Case Reference: HGY/2024/0914

OBJECTION from Chris Hallatt Wells, 13 Stanhope Gdns

Application HGY/2024/0914 (the “**Application**”) is a retrospective planning application to authorise raising the ground level of the driveway and garage forecourt of One Pound Lane, Stanhope Gardens, N6 5TT by up to 700mm.

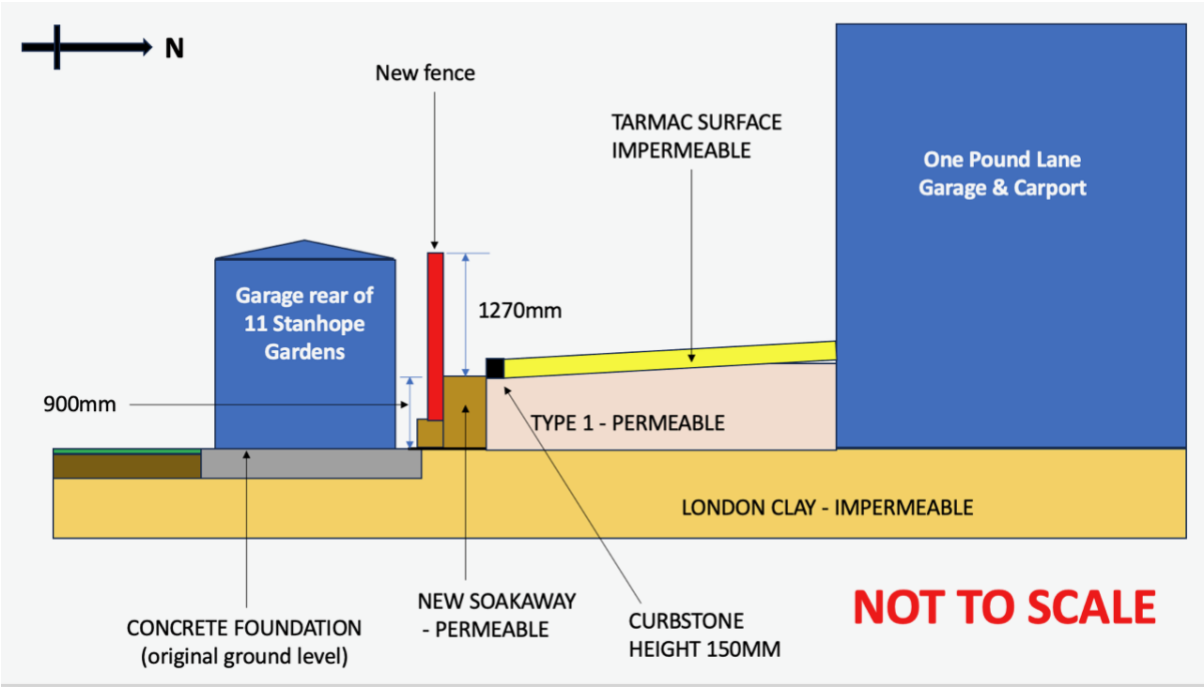
The following examples demonstrate beyond reasonable doubt that the 2023 Technics Plan is materially inaccurate.

We propose that because the information on the change in ground levels provided by the developer has been shown to be inaccurate in these separate locations, all information on the change in ground levels it should be considered suspect and cannot be relied upon to make a determination.

Drawing showing the change in ground levels between 2016 and 2024. This can be confirmed by a site inspection

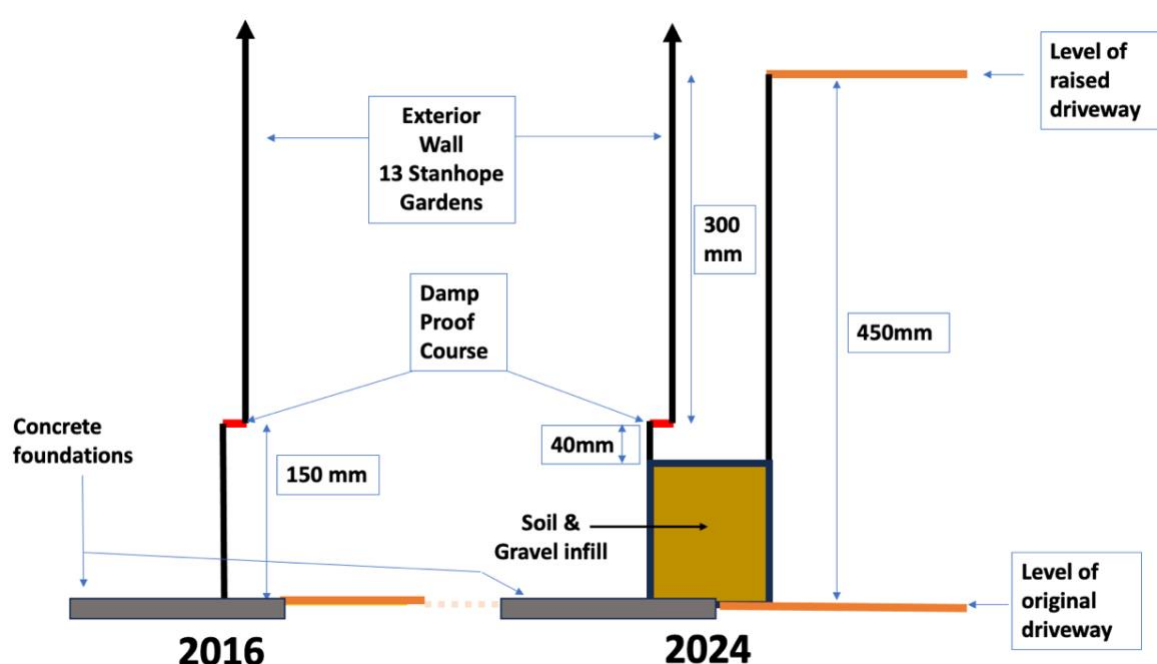
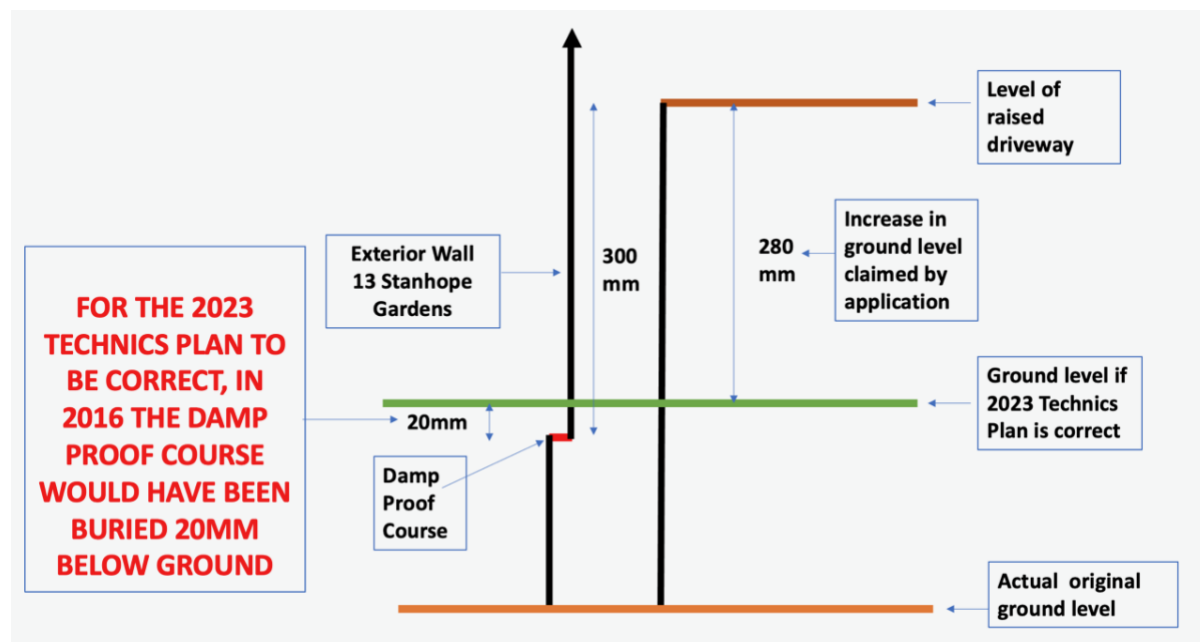
ISSUE	DESCRIPTION	EVIDENCE
Increase in ground level above the damp proof course ("DPC") of 13 Stanhope Gardens	Prior to the building of One Pound Lane the DPC of the side extension of 13 Stanhope Gardens was at least 150mm above the adjacent ground and the original driveway. The ground level of the driveway is now 300mm above the level of the DPC. This indicates that the ground level has been raised at least 450mm (i.e. 150mm + 300mm). The 2023 Technics Plan incorrectly shows that the ground has only been increased by 280mm	• Drawings below • Photograph • Independent GPS site survey comparing ground levels in 2016 & 2024 • Site visit

The 2023 Technics Plan shows incorrectly that the ground level has only been increased by 280mm. If the 2023 Technics Plan was correct the DPC of 13 Stanhope Gardens would have been 20mm below ground in 2016 (see drawing below).

The evidence shows that the clearance between the DPC and adjacent ground from 2016 (until the ground level was raised) was at least 150mm as required by Building Regulations. The 2023 Technics plan must therefore be incorrect.

Image 1

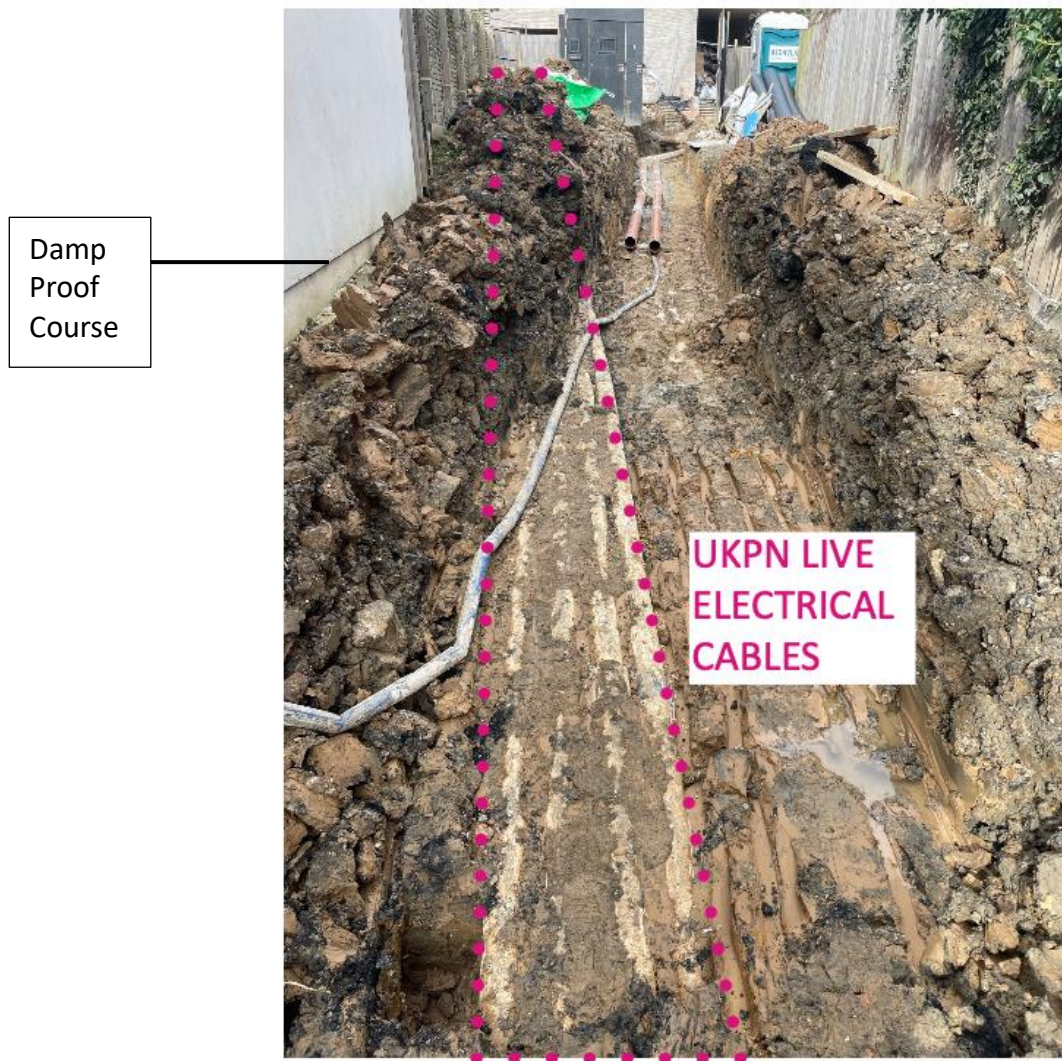
Image 1 shows that the damp proof course of 13 Stanhope Gardens (on the left side of the picture) was above the level of the adjacent ground even whilst the excavation of the driveway to install services was underway. Note that Image 1 was submitted by the developer in its application.

Image 1 was taken before May 2023

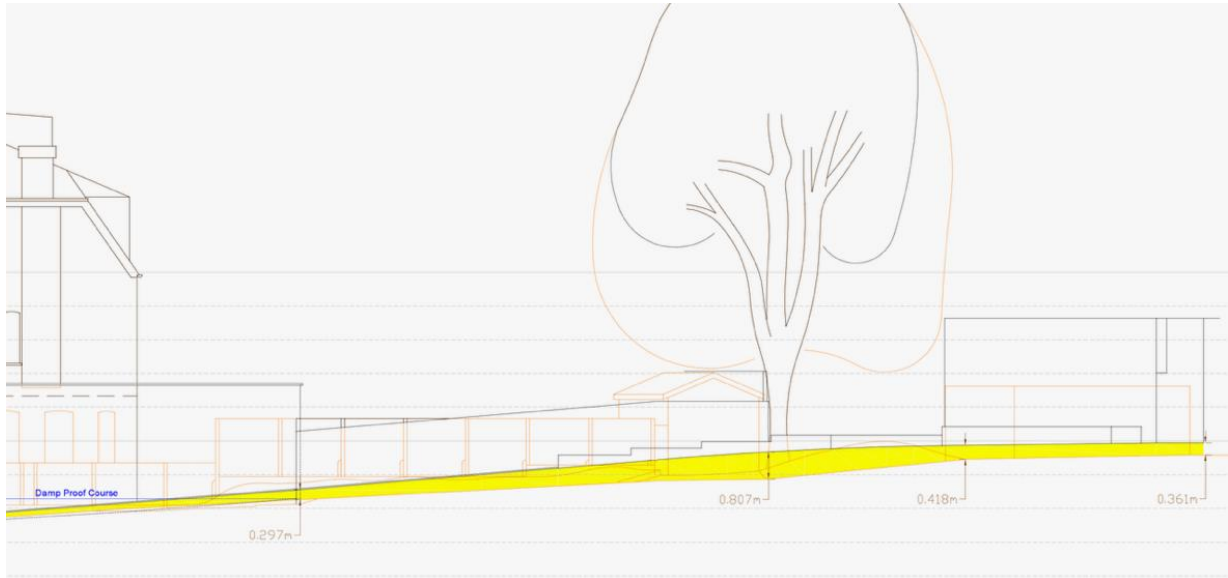
- D. Photographs taken in August 2023 after the ground level was raised in breach of planning control.

E. Independent GPS site survey showing the change in the profile of the driveway between 2015 and 2024

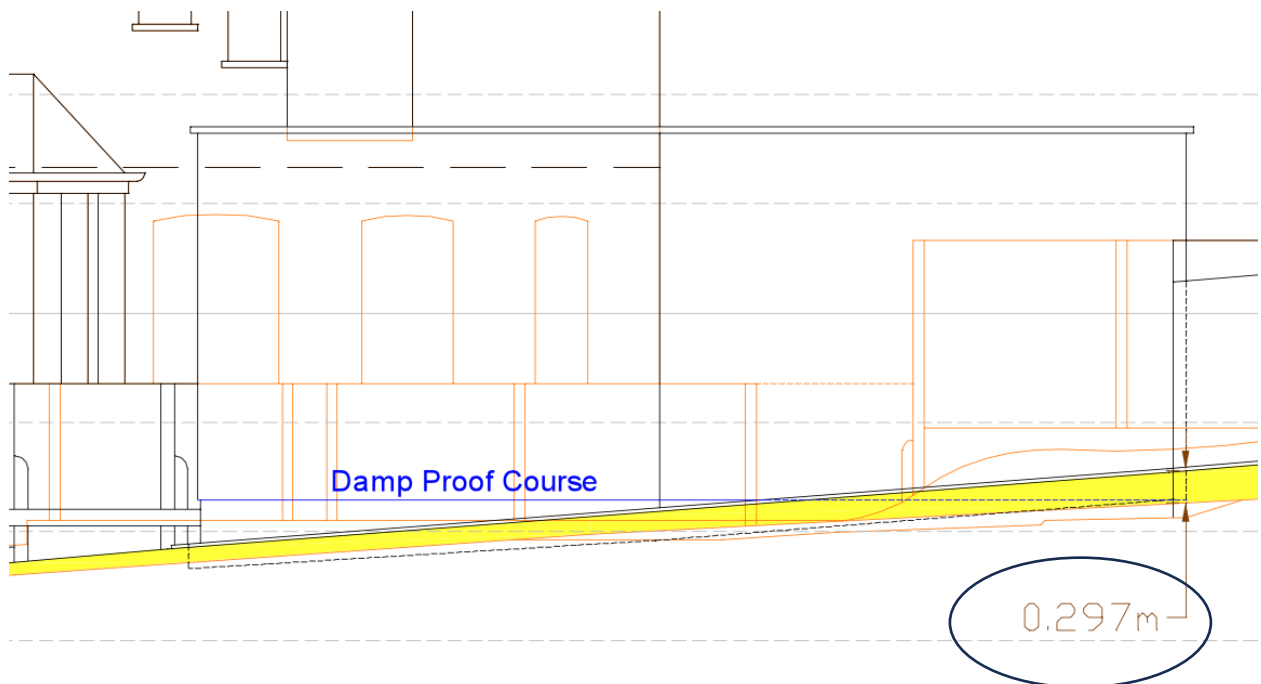
Extract from the first survey highlighting the change in the level of the driveway relative to the height of the damp proof course of 13 Stanhope Gardens.

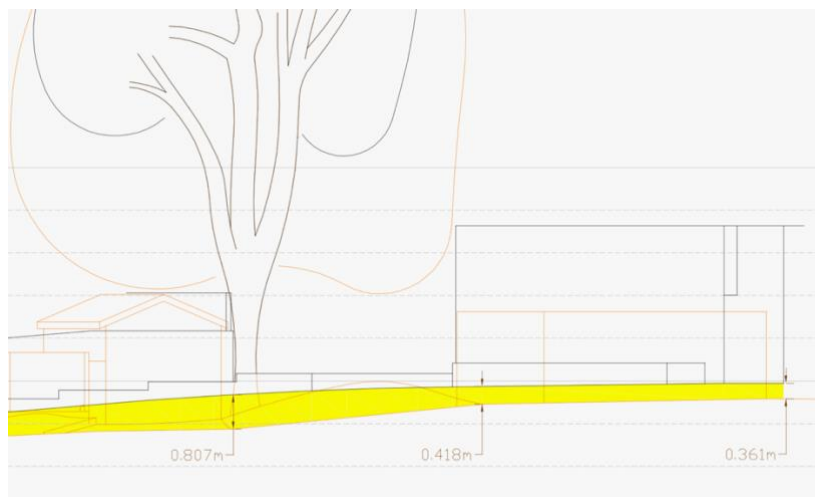
“This document also sets out the proposed drainage provisions including the new soakaway strip along the boundary which will greatly improve on the previous situation and has been designed to prevent water runoff onto neighbouring properties.”

- Prior to the unlawful increase in the ground level water did not drain freely into the gardens of no 9 and 11 Stanhope Gardens. A low earth bank along the boundary between the site and 7, 9 & 11 Stanhope Gardens directed water away from the boundary and into rainwater drainage.

- The soakaway is not an improvement on the previous situation. Breaching building control regulations resulting in a new permanent risk of flooding is not an improvement.

- As the Application states, the soakaway strip is along the boundary with 11 Stanhope Gardens:
 - Building Regulations prohibit the installation of a soakaway within 1.5 meters of a boundary and within 5 meters of a building.

- The soakaway is less than 1 meter from the garage at the rear of 11 Stanhope Gardens. A garage falls within the legal definition of a building for the purposes of Building Control.

- The soakaway will not prevent water runoff onto neighbouring properties because the soakaway is above the adjacent ground (see photograph below) As the application notes, the soil type is impermeable clay. Water entering the soakaway will percolate through the soakaway until it reaches the impermeable clay. It will then drain freely into the gardens of 9 and 11 Stanhope Gardens.

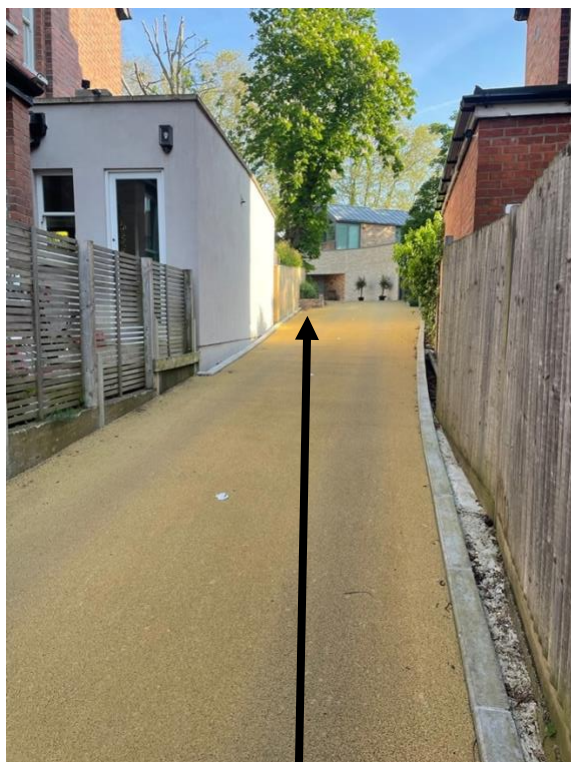
Weep holes are
not visible

Soakaway

The base of the soakaway is above the level of the grassed lawn of 13 Stanhope

Raised flower bed

Weep holes:

Cosmetic not functional.

The weep holes are above level of adjacent garden.

A retaining wall has not been installed along the boundary with 13 Stanhope Gardens. Water will drain freely into Stanhope Gardens before it reaches the weep holes.
